ADDENDUM NO. ONE (1)
CITY OF STATHAM, GEORGIA
OAK STREET SPRING IMPROVEMENTS
ISSUED March 27, 2026

RE: OAK STREET SPRING IMPROVEMENTS
EMI PROJECT No. 24-012

This Addendum forms a part of the Contract Documents and Drawings and modifies the original bidding documents dated FEBRUARY 2026.

M3

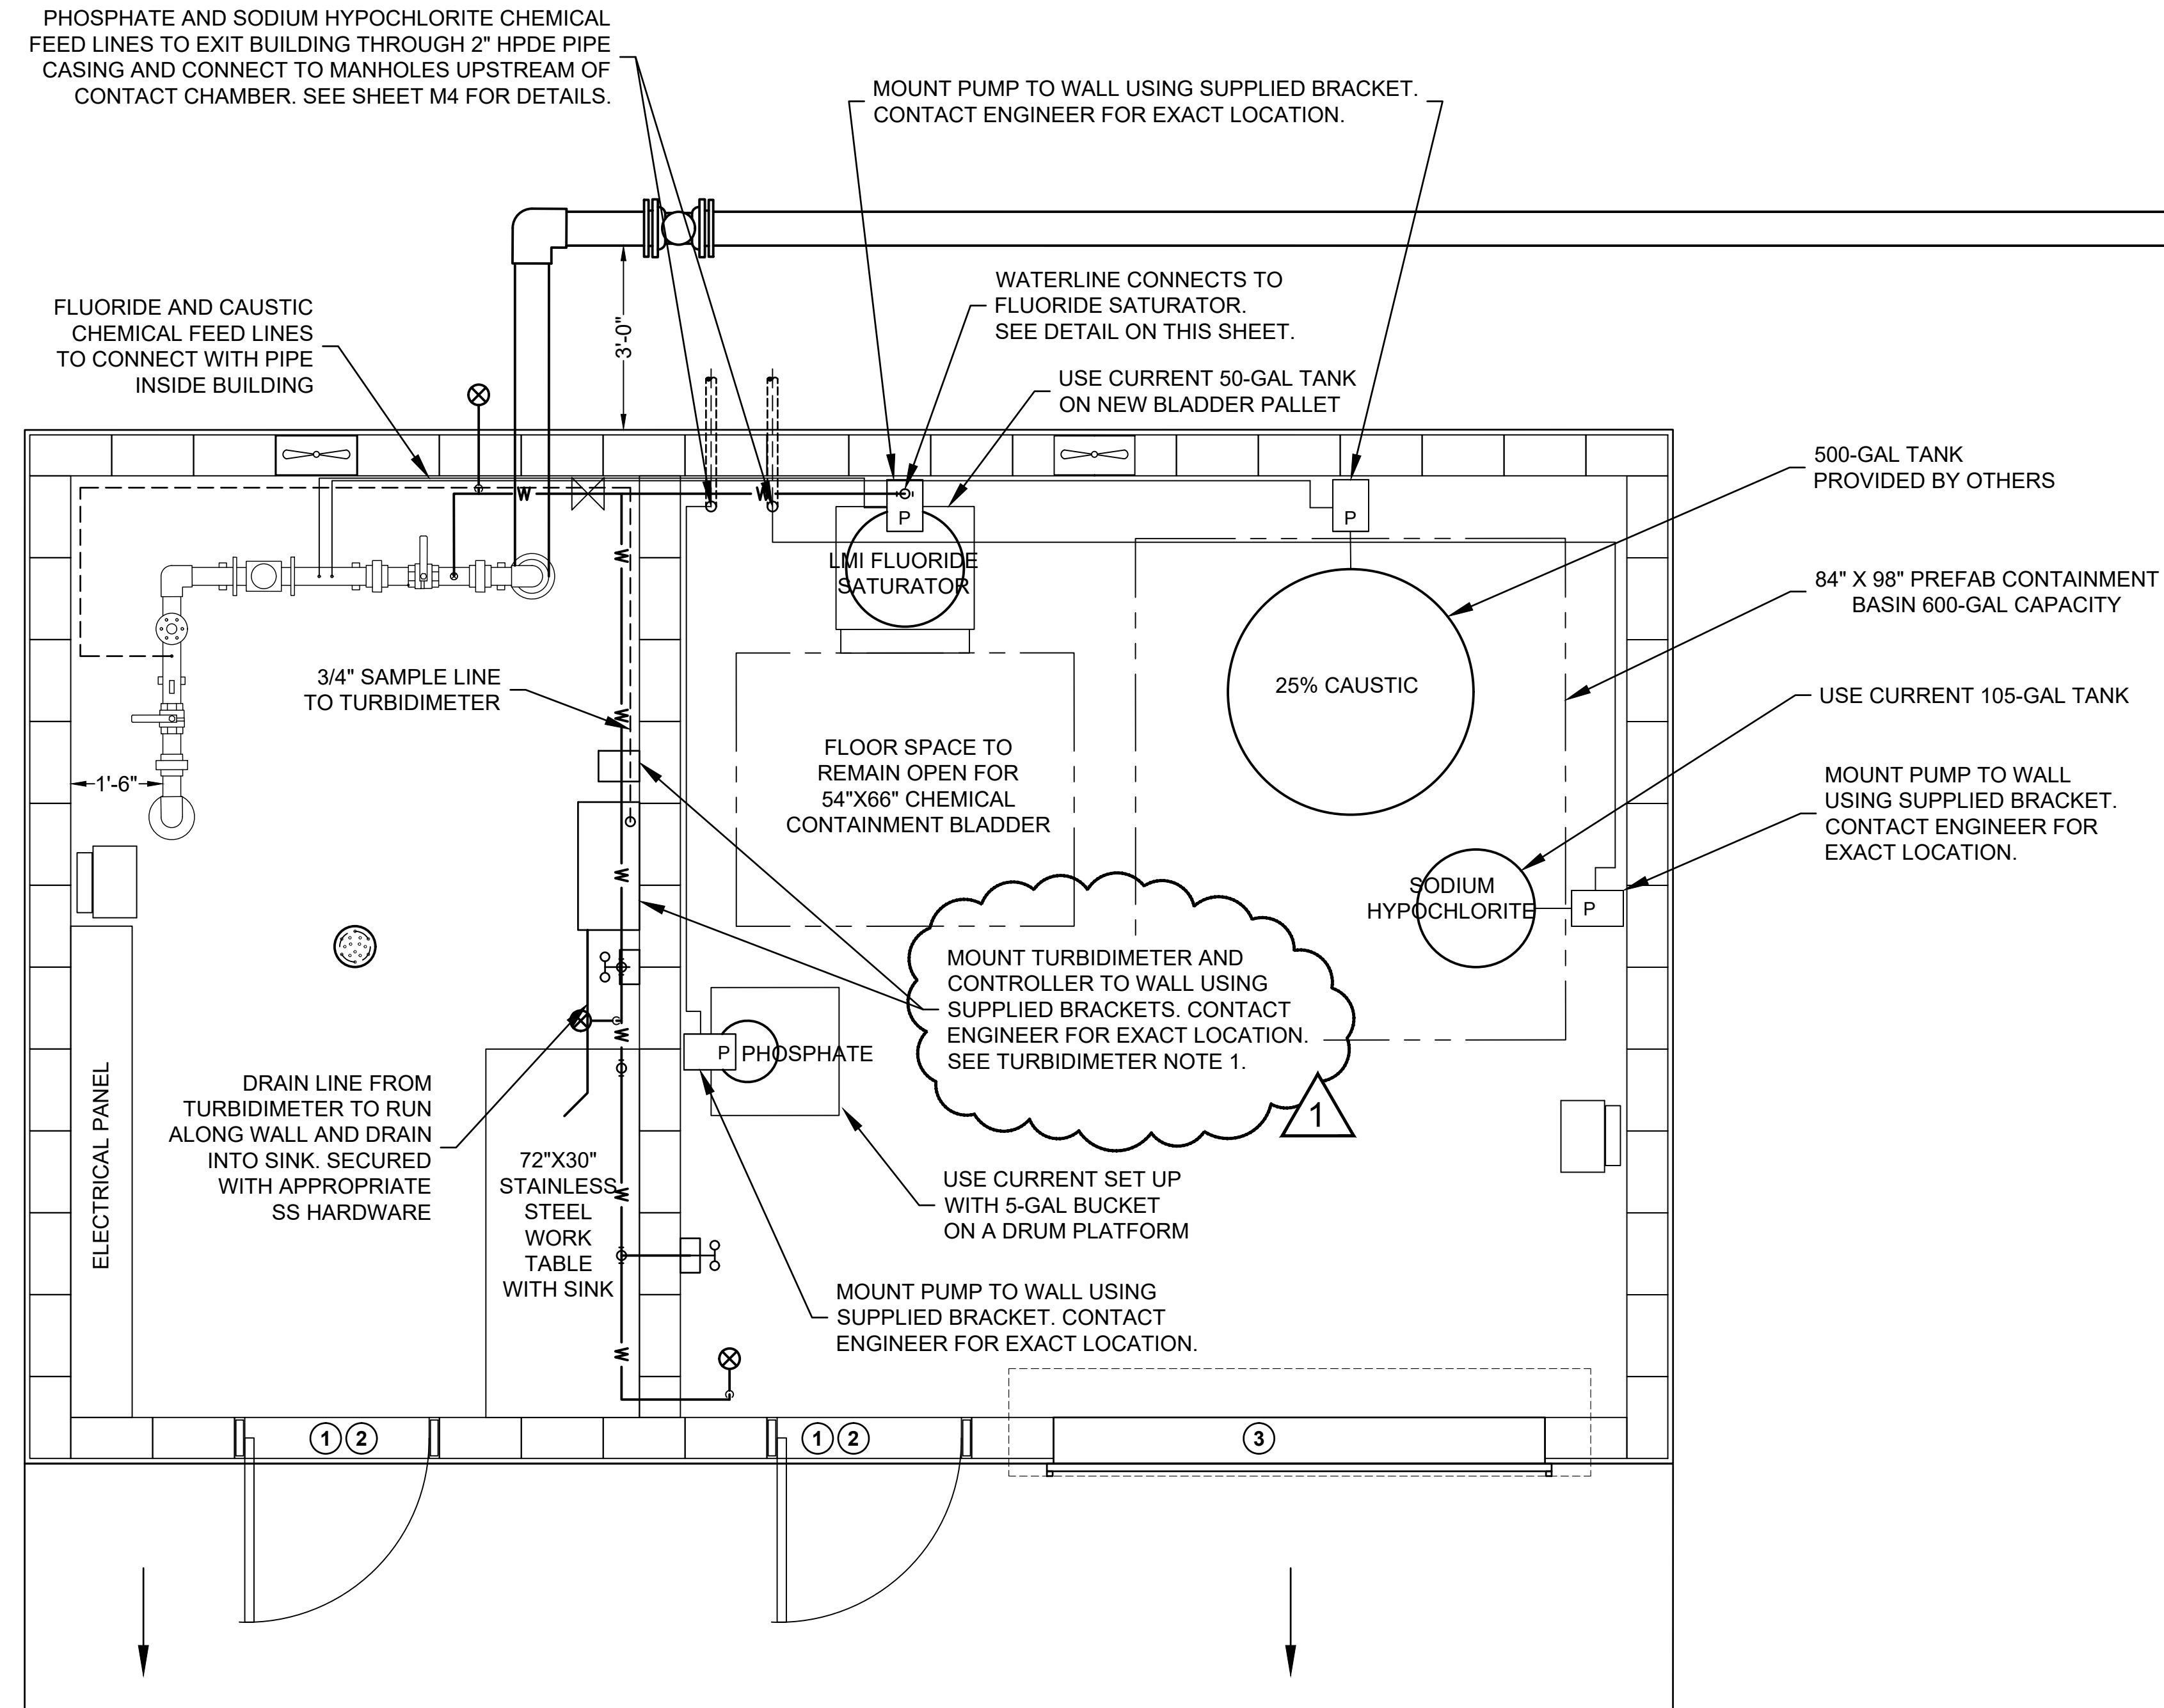
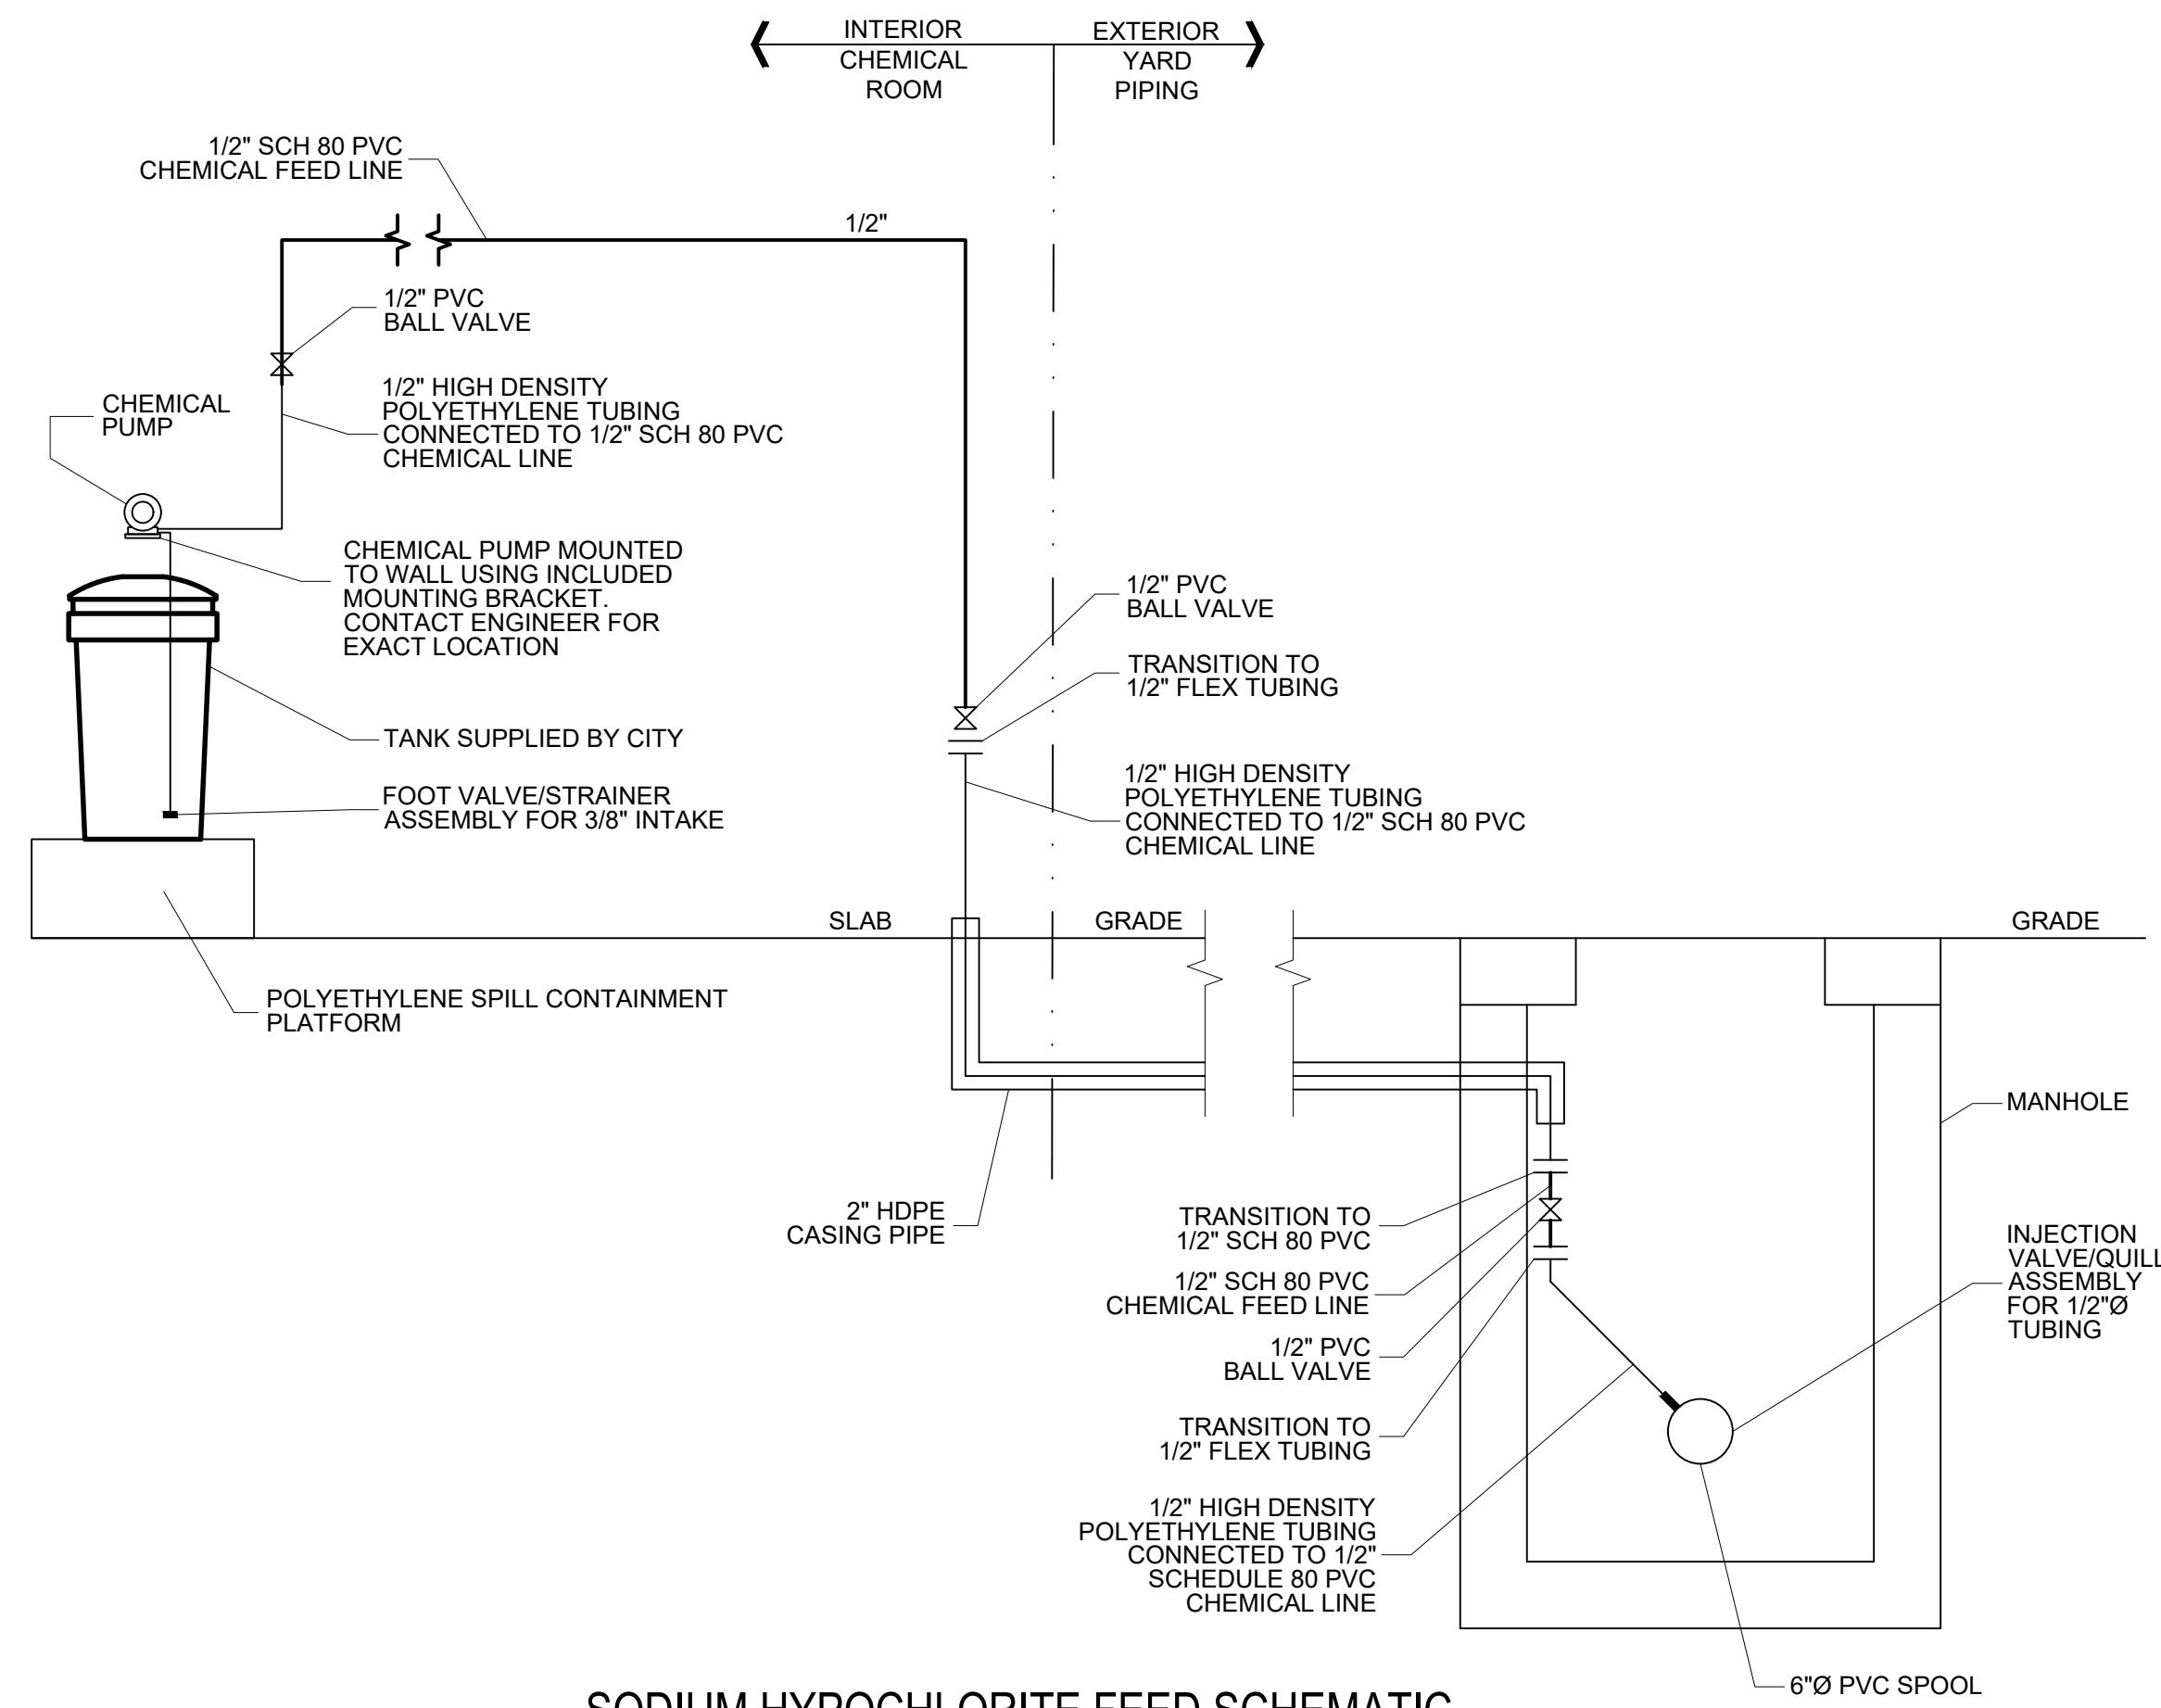
- Plan sheet M3 has been revised as follows. See attached revised plan sheet. (revisions are shown with revision clouds)
 - **Turbidimeter Notes have been added detailing the needed connections to SCADA and pump control when NTU values are exceeded.**

1. TURBIDIMETER SHALL BE WIRED SUCH THAT EXCEEDING A SET NTU VALUE WILL SHUT OFF THE SUBMERSIBLE. THE TURBIDIMETER SHALL ALSO BE WIRED TO THE SCADA SYSTEM FOR MONITORING AND NTU RECORDING.
2. SEE SPECIFICATION SECTION 13421 FOR ADDITIONAL INFORMATION.

FLUORIDE FEED SCHEMATIC
NOT TO SCALE

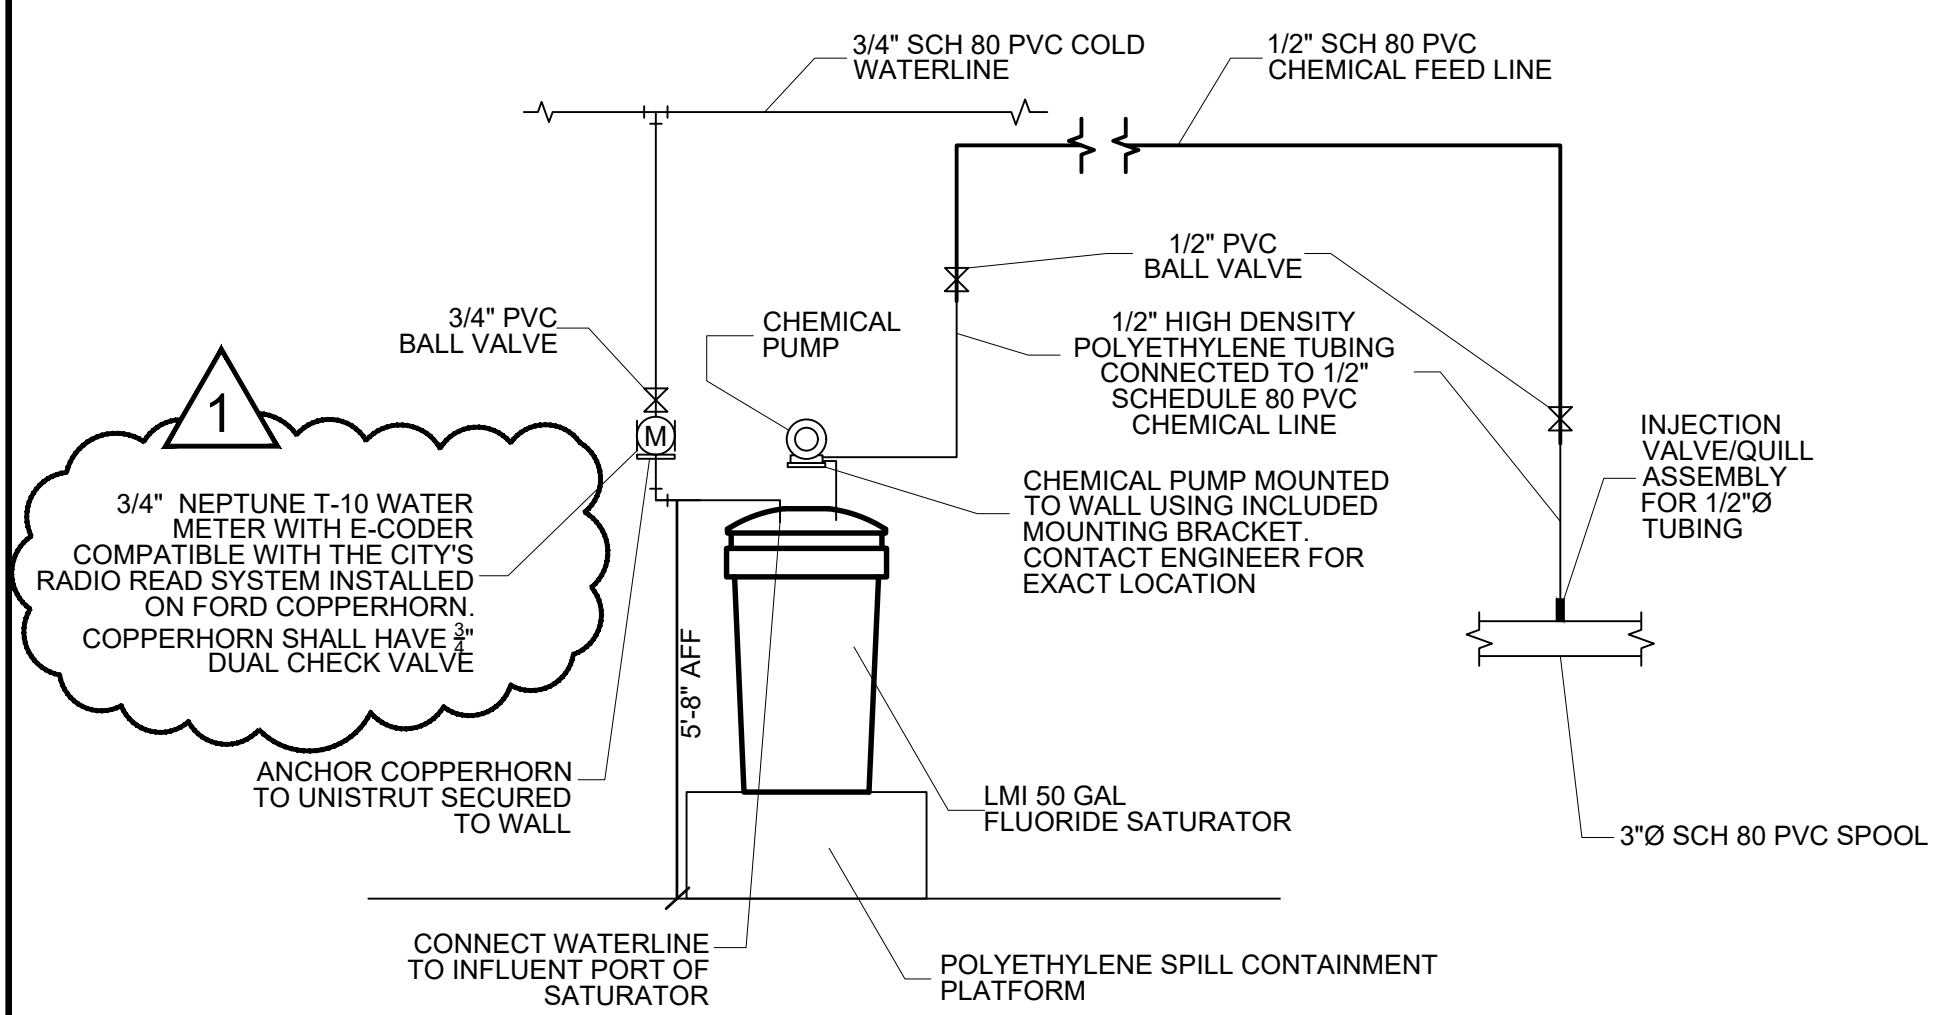
- Plan sheet M4 has been revised as follows. See attached revised plan sheet. (revisions are shown with revision clouds)
 - **The ¾" meter for the fluoride feed has been changed to a Neptune T-10 meter with E-coder to match the City's existing meter system.**
